**AVIATION INVESTIGATION REPORT
A08P0011**

LIMITED POWER – HARD LANDING

**PRISM HELICOPTERS LIMITED
EUROCOPTER AS 350-B3 (HELICOPTER) N530NA
PITT MEADOWS, BRITISH COLUMBIA, 2 nm W
10 JANUARY 2008**

BEA comments
about
the draft investigations report of AS 350 B3 accident registered N530NA

Photo 4. O-ring material and metering valve

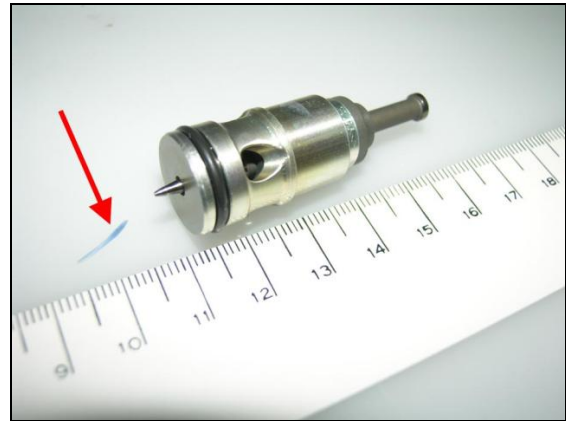
“A detailed disassembly and examination of the HMU by Turbomeca, Thales, the Bureau d’Enquêtes et d’Analyses (BEA), and TSB Engineering personnel revealed the presence of a contaminant within the HMU fuel channels. This contaminant was determined to be a small sliver of O-Ring seal material (see Photo 3 and Photo 4). There was no metal generated within this component”

Turbomeca Investigation report (T08CRA0308A-1 on 5 July 2008) noticed that a piece of blue O’ring was discovered in the Delta P diaphragm chamber during HMU disassembly.

No Turbomeca opinion about what could have been the consequence of such piece in this chamber is noticed in the report.

According to Turbomeca, *“it is impossible for the sliver found in the HMU to obstruct the fuel metering valve”*. In addition, Turboméca stated that *“if this sliver had gone through the fuel metering valve, there is very low probability that it would end up in the delta P diaphragm; it would have gone with the fuel flow.”*

It seems useful to study if complementary tests with a standard HMU with such similar piece of O’ring could be carried out in order to determine if this piece could have been involved in a fixed fuel flow conditions.
